# **Alert J784S2 vE5 & J742S2 vE2 EVM System Updates**

**Notifying customers of EVM performance updates across both  
J784S4 & J742S2 EVMs and any J7 design using a universal PDN-3x scheme.**

**V1.0      9/12/2024**

# J784S4 (PROC141E5) & J742S2 (PROC184E2) Key Updates

## • Update #1: HCPS-A, 3-Phase Buck for VDD\_CPU\_AVS

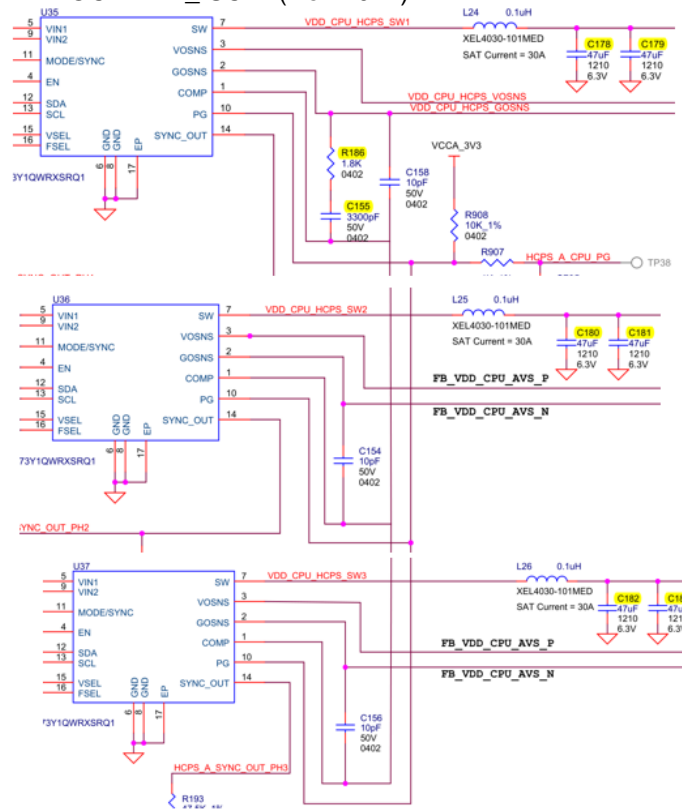
- $C_{z\_out}$  per phase = 47uF  
(Note:  $C_z = C_{nom}$  derated by 50%)
- $C_{nom\_out}$  per phase = 94uF (C178 & 179; C180 & 181; C182 & 183)

- $C_{z\_out}$  per phase = 11uF
- $C_{nom\_out}$  per phase = 22uF (C178; C180; C181)
  - PN: GCM32ER70J226KE19L, CERAMIC 22uF 6.3V 10% X7R AUTO 1210
  - DNI 3x capacitors (C179; C181; C182)

## • Update #1: HCPS-A, 3-Phase Buck for VDD\_CPU AVS

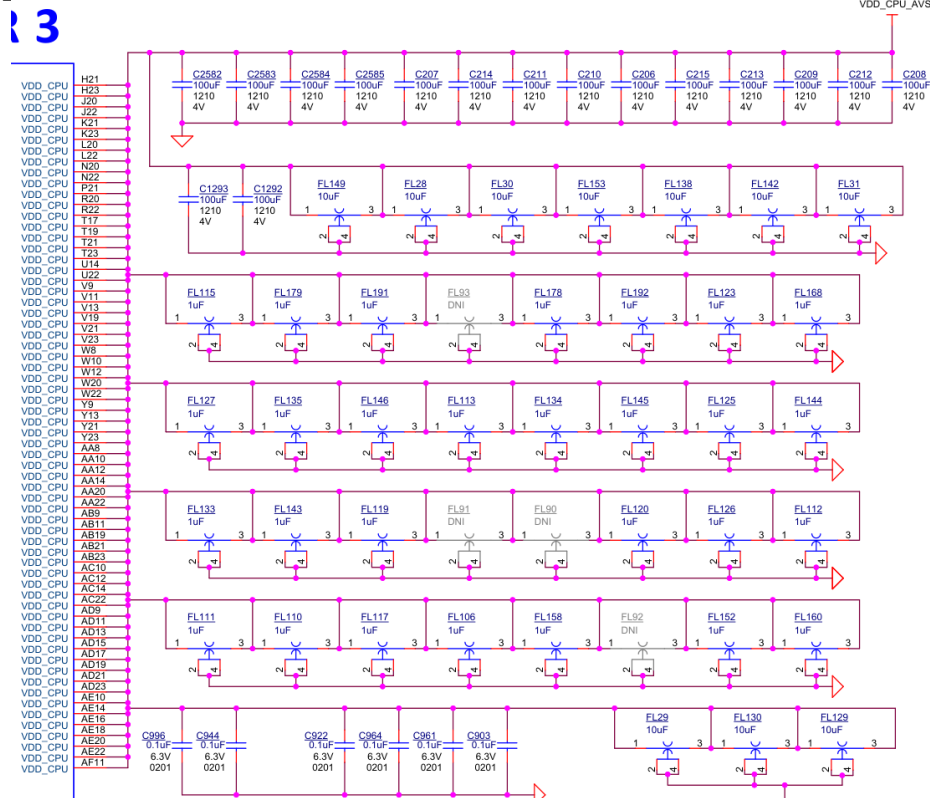
- PoL Cz =  $1698 \times 50\% = 849\mu\text{F}$   
( $1698 \times 47\% = 900\mu\text{F}$ )
- $C_{nom\_load} = (16 \times 100\mu\text{F} + 7 \times 10\mu\text{F} + 28 \times 1\mu\text{F})$   
( $1600 + 70 + 28$ ) =  $1698\mu\text{F}$

### – PROC141E5\_SCH No Impacts for 47% derating

## • Update #2: HCPS-B, 2-Phase Buck for VDD\_CORE\_OV8

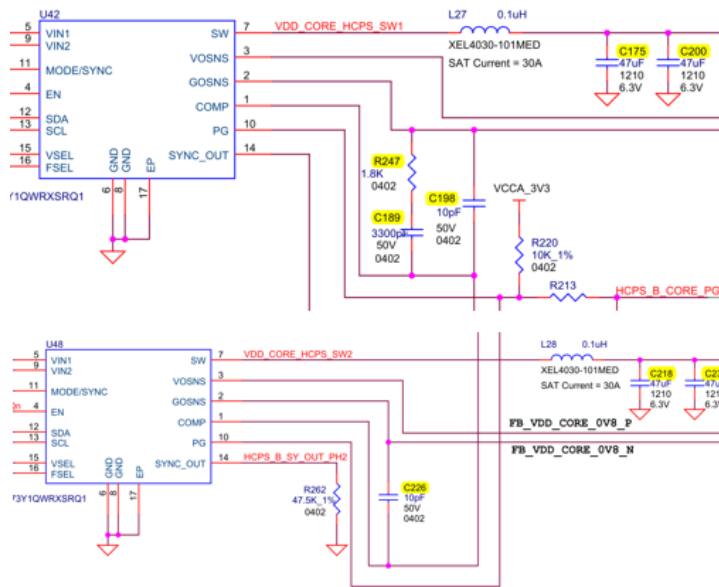
- $R_z = 1.8k$  (R247)
- $C_c = 3,300pF$  (C189)
- $C_{c2} = 10pF$  (C198 & C226)

- $R_z = 1.2k$  (R247)
- $C_c = 4,700pF$  (C189)
- $C_{c2} = 20pF$  (C198 & C226)

- $C_{z\_out}$  per phase = 47uF  
(Note:  $C_z = C_{nom}$  derated by 50%)
- $C_{nom\_out}$  per phase = 94uF (C175 & C200; C218 & C236)

- $C_{z\_out}$  per phase = 23.5uF
- $C_{nom\_out}$  per phase = 47uF (C175; C218)  
– DNI 2x capacitors (C200; C236)

## • Update #4: PMIC GPIO8 connections

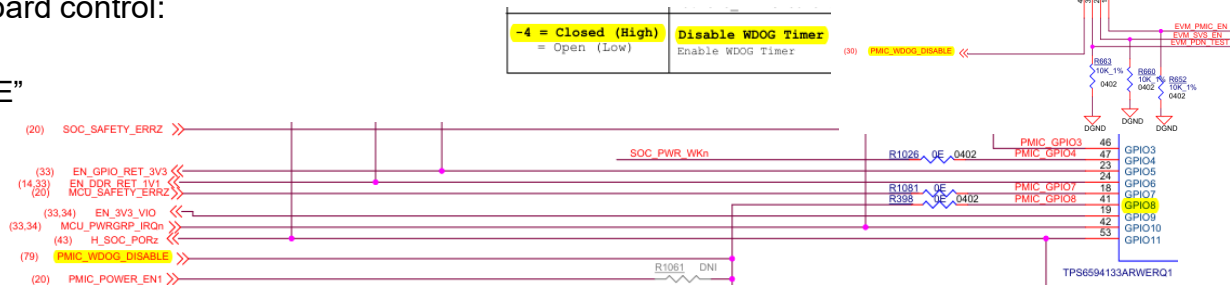
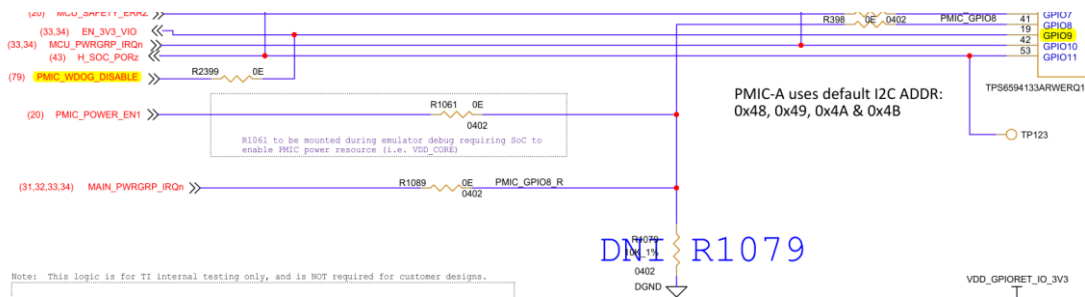
- PROC141E3/E4\_SCH
  - Originally “PMIC\_WDOG\_DISABLE” net connected to R398 (0-ohm) & interface to PMIC GPIO8

- PROC141E5\_SCH (Impacts)  
GPIO8 now supports a new “PDN Type”  
PMIC initialization control

Example: MAIN\_PWRGRP\_IRQn net connected to GPIO8 for EVM’s Isolated MCU & Main PDN-3A. Net is held low by low-voltage translator to keep HCPS-A & -B disabled until correct power up seq time step. Therefore, GPIO8 (PDN Type) latches a logic low to set Isolated MCU & Main PDN type.

## • Example PMIC GPIO8 connection for Grouped MCU & Main PDN-3G thru -3M

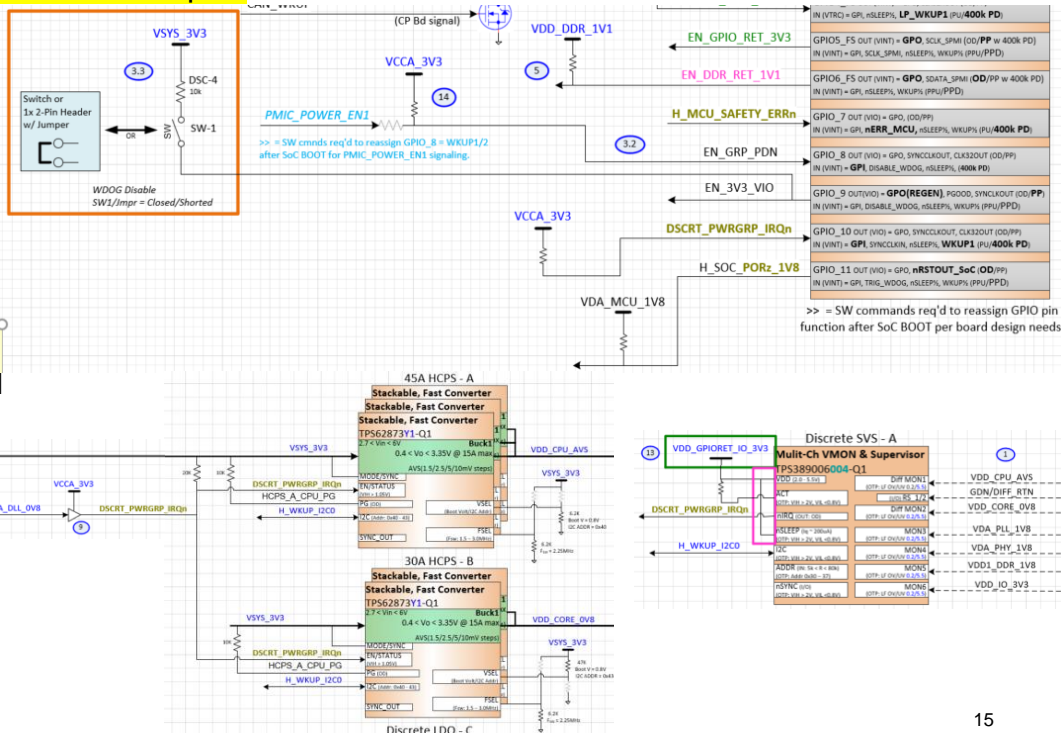
- EN\_GRP\_PDN net connected to GPIO8 is pulled-up to VSYS\_3V3. Enabling the PMIC to latch a logic high during early portion of power up seq, resulting in Buck5 being disabled & removed from power up seq as desired for Grouped MCU & Main PDN-3G to -3M schemes.
- MCU\_PWRGRP\_IRQn net that is connected to GPIO10 for Isolated PDNs has been renamed to DSCRT\_PWRGRP\_IRQn. This distinguishes that only 1 common IRQn interface to PMIC is needed for both SVS-A & -B to provide VMON coverage across all discrete power resources.
- MAIN\_PWRGRP\_IRQn net that is connected to GPIO8 for Isolated PDNs is no longer needed since MCU & Main supplies are now grouped. Hence, GPIO8 can be used as a new "PDN Type" setting by installing an Rpu.

## • Update #5: PMIC GPIO9 connections

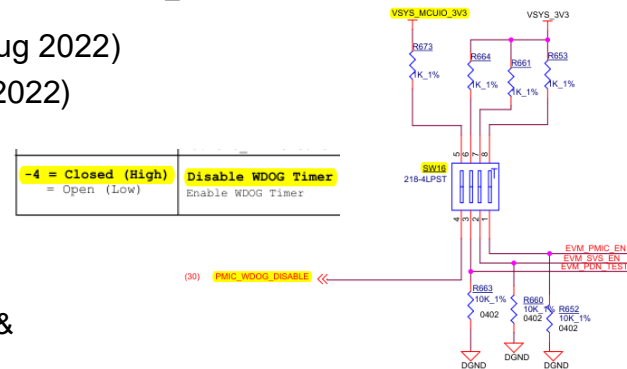
- PROC141E3/E4\_SCH
  - Originally “PMIC\_WDOG\_DISABLE” net connected to R398 (0-ohm) & interface to PMIC GPIO8

- “PMIC\_WDOG\_DISABLE” net moved to GPIO9

- **Update #6: Clearing asserted MCU\_PWRGRP\_IRQ**
- Safety Voltage Supervisors (TPS389006004-Q1) supply connection

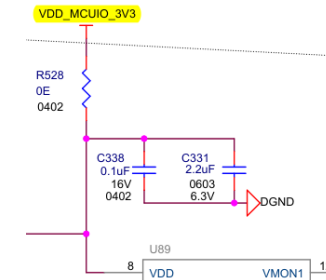
- Connected to VCCA\_3V3 = “always on” VSYS\_3V3

- Connect to VDD\_MCUIO\_3V3 supplied from PMIC LDO2 for PDN-3A to -3F.

- Connect to VDD\_GPIORET\_IO\_3V3 supplied from PMIC LDO2 for PDN-3G to -3M.  
(Source remains the same but net name changes due to Grouped MCU & Main PDN type.)

- Update #7: Improve discrete LDO slew rates
- Remove TPS74501P-Q1 optional feed-forward caps (Cff)
  - PROC141E4\_SCH
    - C192, C274 & C334 = 0.01uF
  - PROC141E5\_SCH (Impacts)
    - Remove C192, C274 & C334

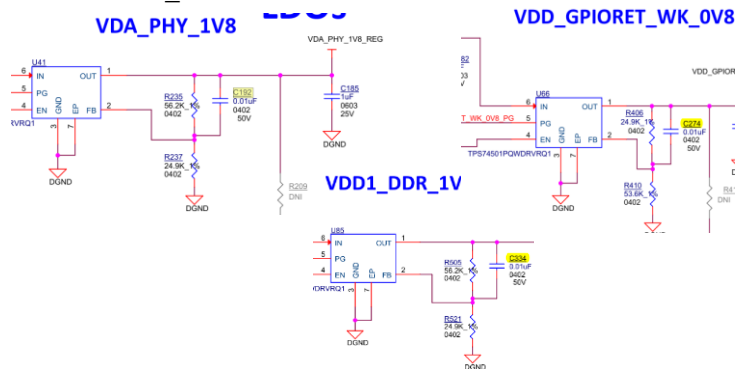
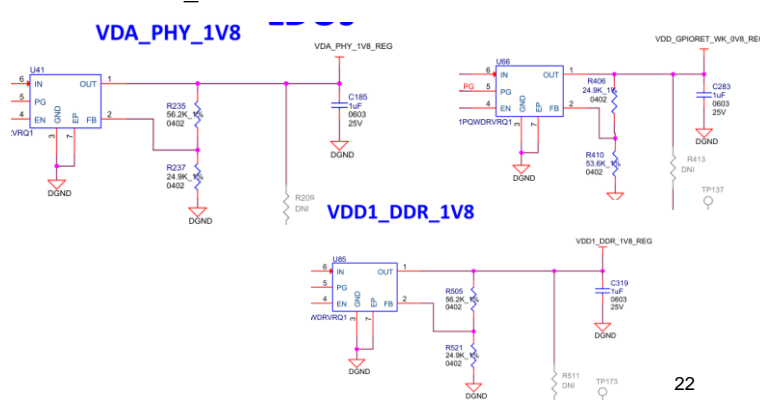
- **Criticality:** Medium
- **Description:** Discrete LDOs (TPS74501P-Q1) used to supply power rails VDD\_PHY\_1V8, VDD\_GPIORET\_WK\_0V8 & VDD1\_DDR\_1V8 have excessive ramp-up & down slew rates impacting desired power sequences. Optional feed-forward caps (Cff) were installed for improved noise & PSRR performance but previous J7 EVMs have not needed or used Cff caps.
- **Key Updates (Impacts):**
  1. Remove optional 0.01uF feed-forward caps (Cff) from all 3x TPS74501P-Q1 LDOs

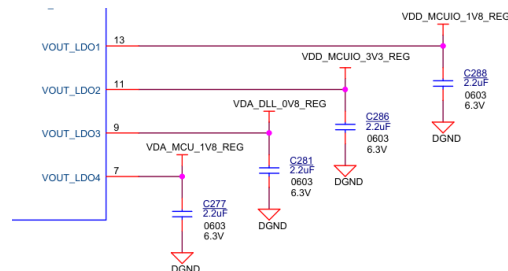
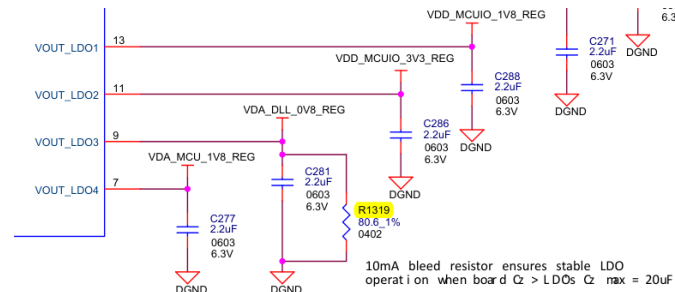
- **Criticality:** Low
- **Description:** PMIC's LDO3 output voltage stability for output capacitance exceeding data sheet max rating of 20uF at cold temperatures can be improved by installing a 10mA “bleed resistor” per PMIC team recommendation.
- **Key Updates (Impacts):**
  1. Add a 10mA “bleed resistor” on LDO3 Vout for a minimum load to avoid possible supply oscillations at low temperatures following LDO enabling with no load prior to booting SoC.

- **Update #8: PMIC LDO3 Coz > 20uF capacitance**
- LDO3 supplies power rail VDA\_DLL\_0V8
  - PROC141Ex\_SCH
    - VDA\_DLL\_0V8 rail supports 4x DDR & 1x MMC0 PLL input supplies that require low freq, low noise performance with 1.0 & 10uF decoupling caps recommended.
    - $C_{nom\ total} = C_{nom\_local} + C_{nom\_PoL} = 2.2\mu F + 5 \times 11\mu F = 57.2\mu F$
    - $C_z\ total = 57.2 \times 50\% = 28.6\mu F > 20\mu F\ max\ C_z$
  - PROC141E5\_SCH (Impacts)
    - Add 80.6 ohm R1319 to LDO3 Vout
      - 10mA bleed resistor to VDA\_DLL\_0V8
      - Recommended by PMIC team to avoid instability & oscillations especially at start-up when LDO loads are not active yet.

- Update #9: Optional customer eFuse programming

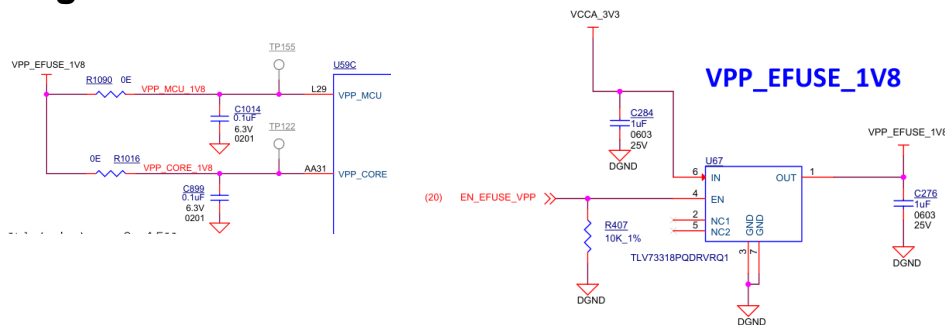
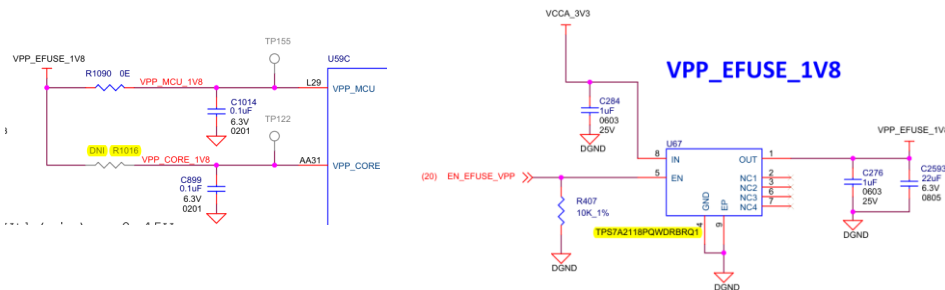
- Originally install 2x 0-ohms at R1090 & R1016
- Originally U67 used a 300mA LDO (TLV73318P-Q1)

- DNI 0-ohm at R1016
- Replace U67 with 500mA LDO (TPS7A2118P-Q1)
